ADDENDUM #3

Project	Holy Family Catholic Elementary School	Project No.	2325
Location	1420 Grosvenor Street, Oakville, ON	Date of Issue	2024 04 09
Owner	Halton Catholic District School Board	File	2325/7.1.3

RE: Holy Family Catholic Elementary School
Renovations
Oakville, ON

ADDENDUM 02

Drawing Title
ROOF PLAN DEMOLITION PHASE 2

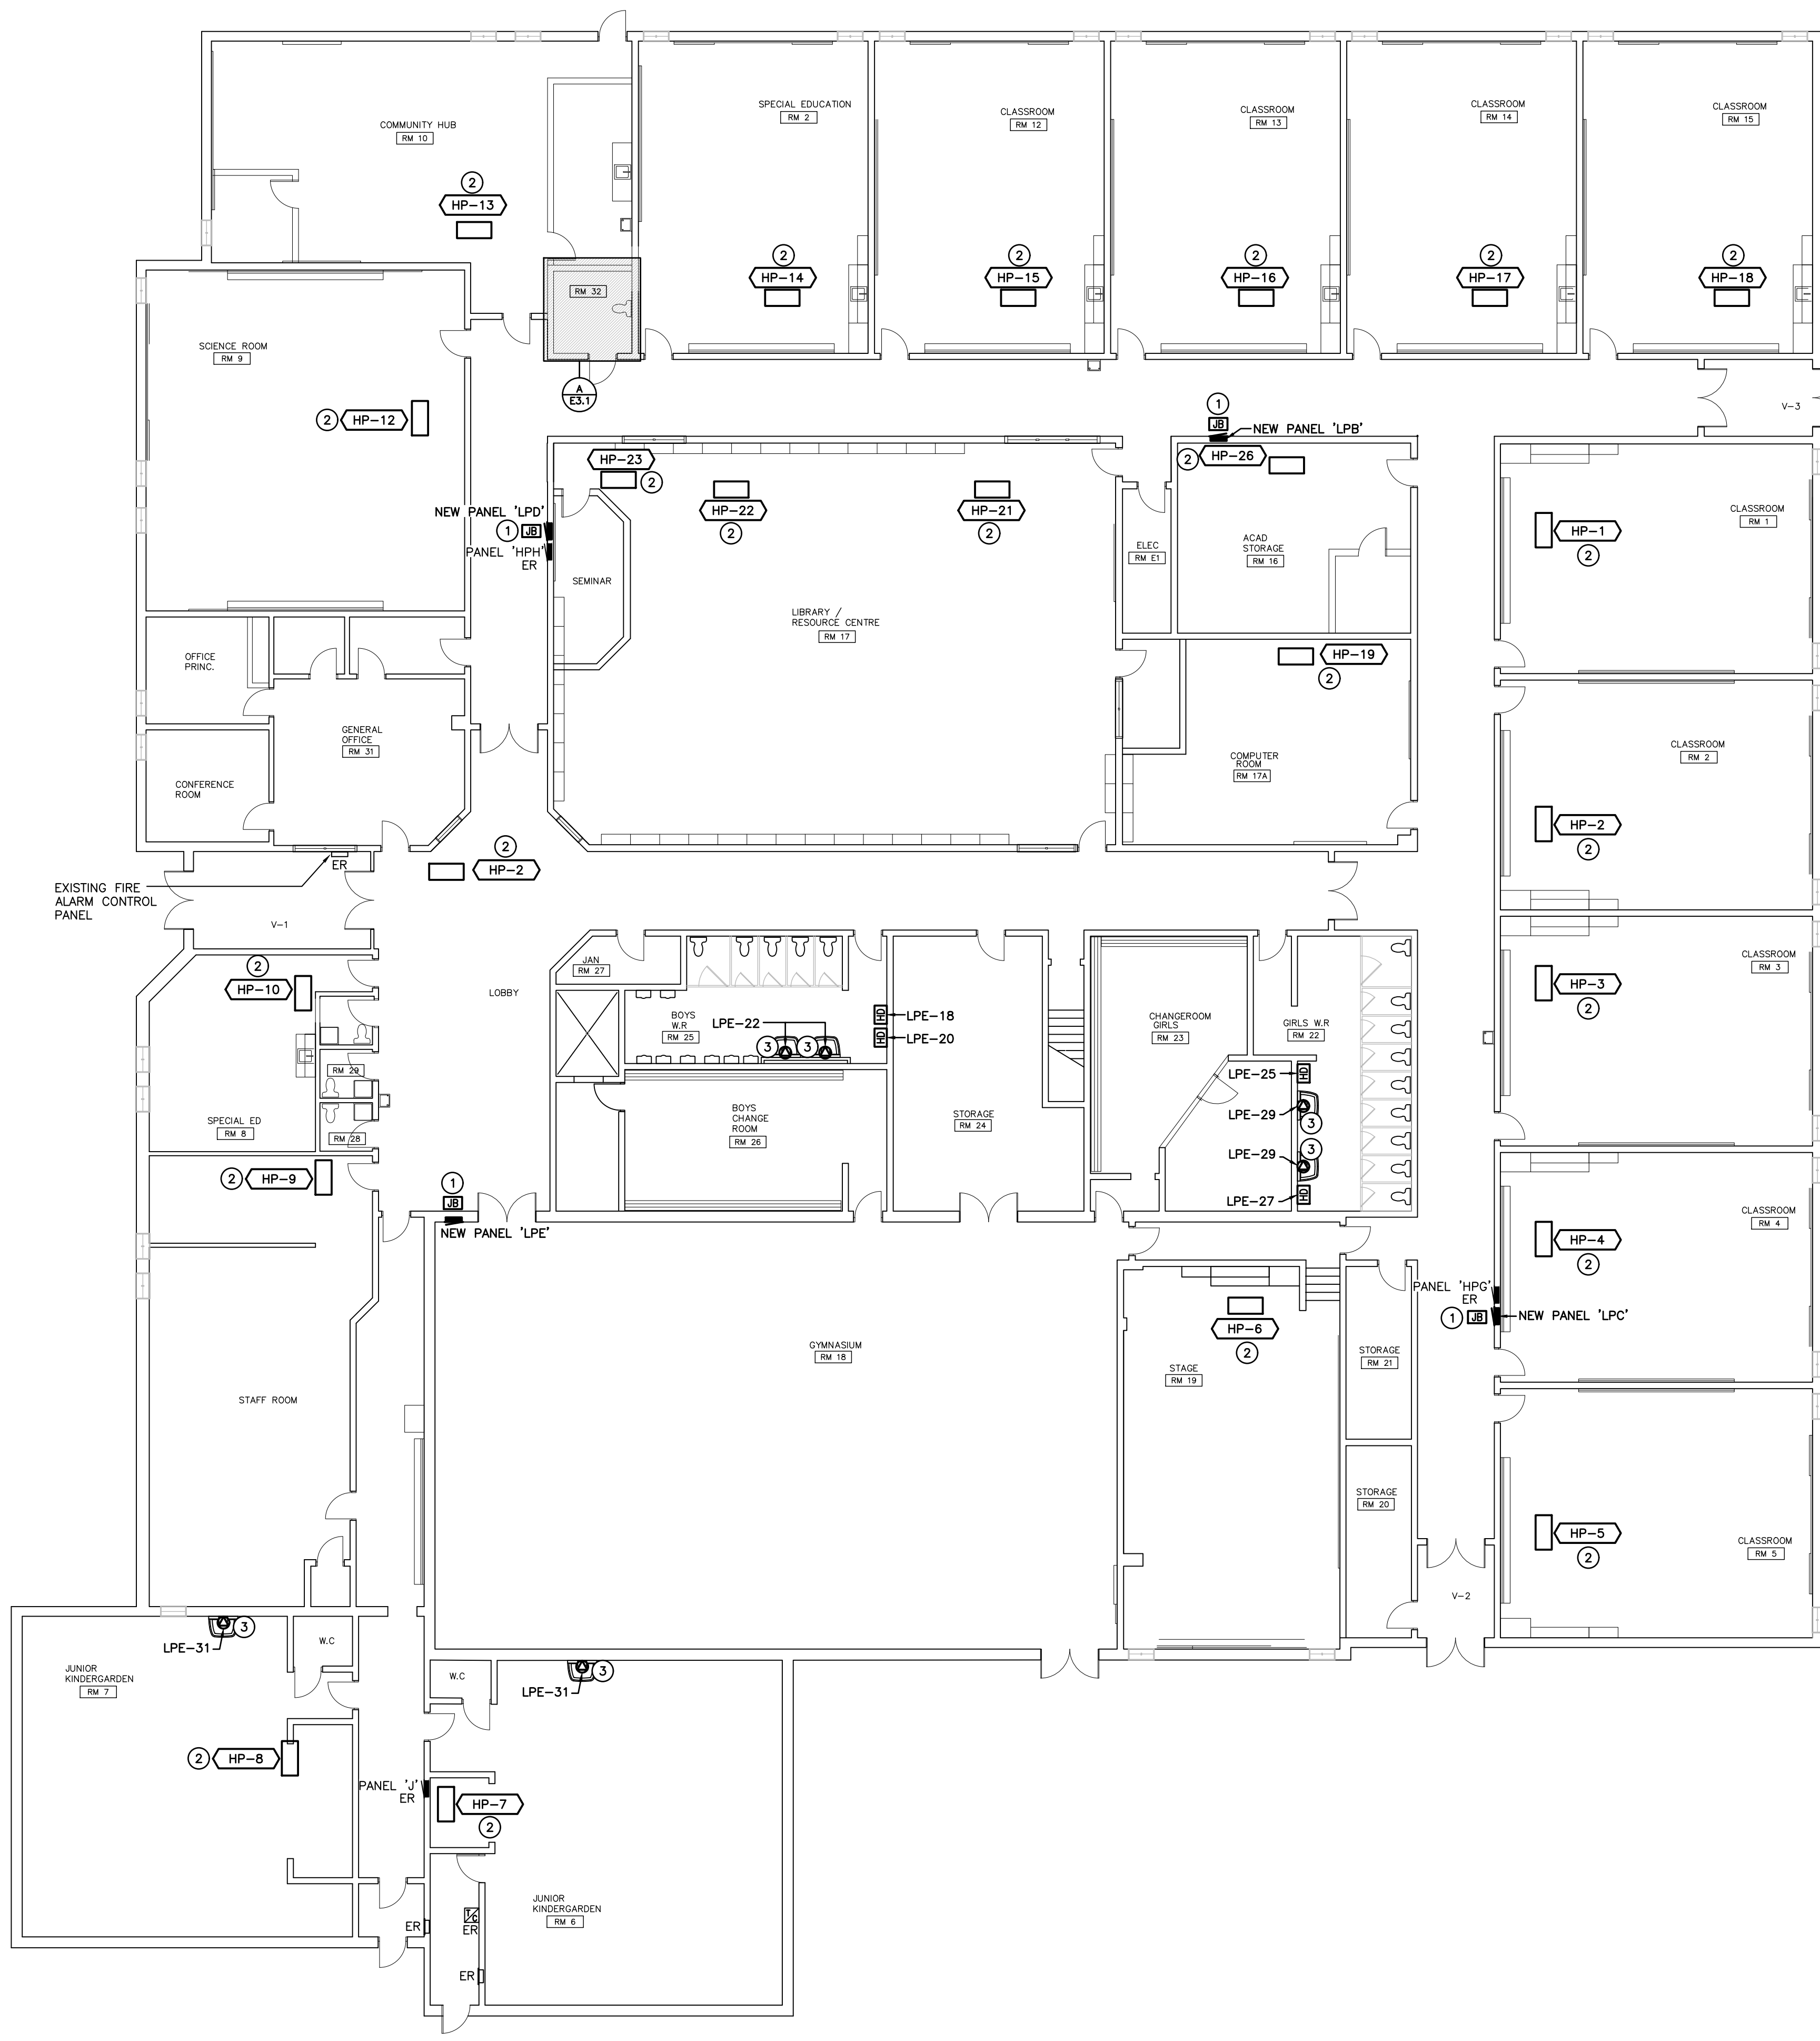
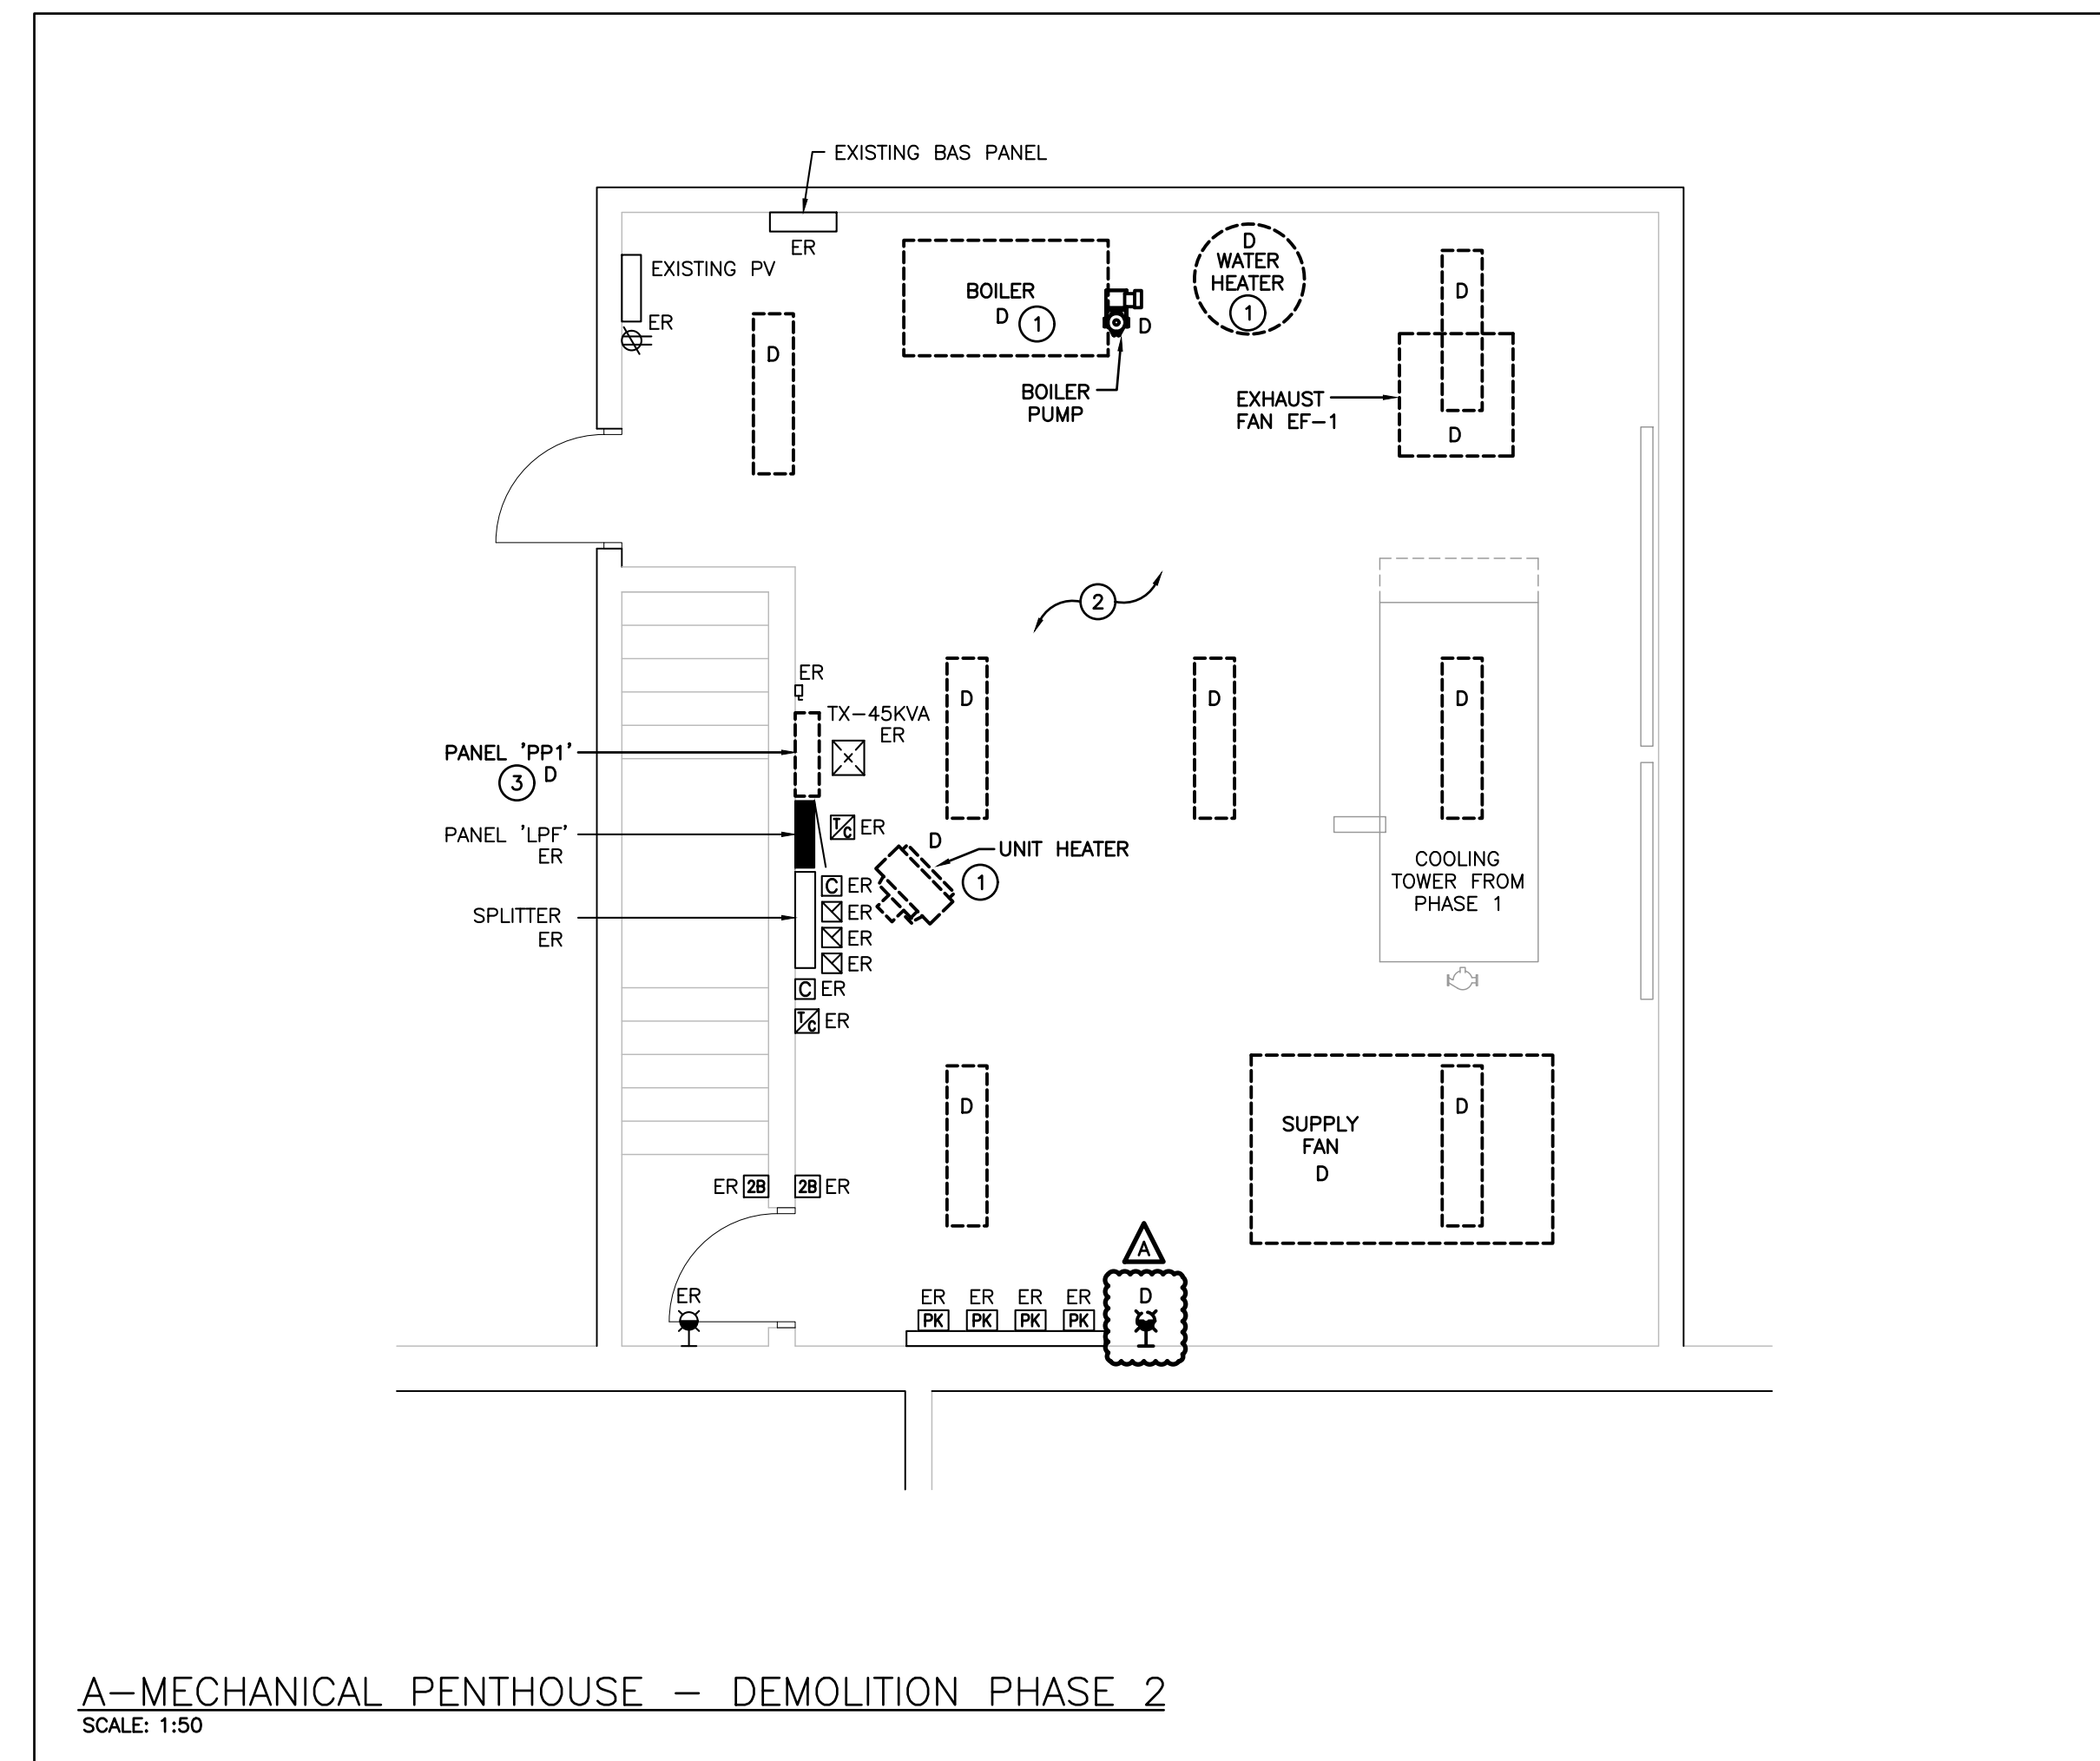
7.0 Reference Attached Reissued Drawing E2.3

- .1 Demolish existing single emergency remote head within mechanical penthouse.
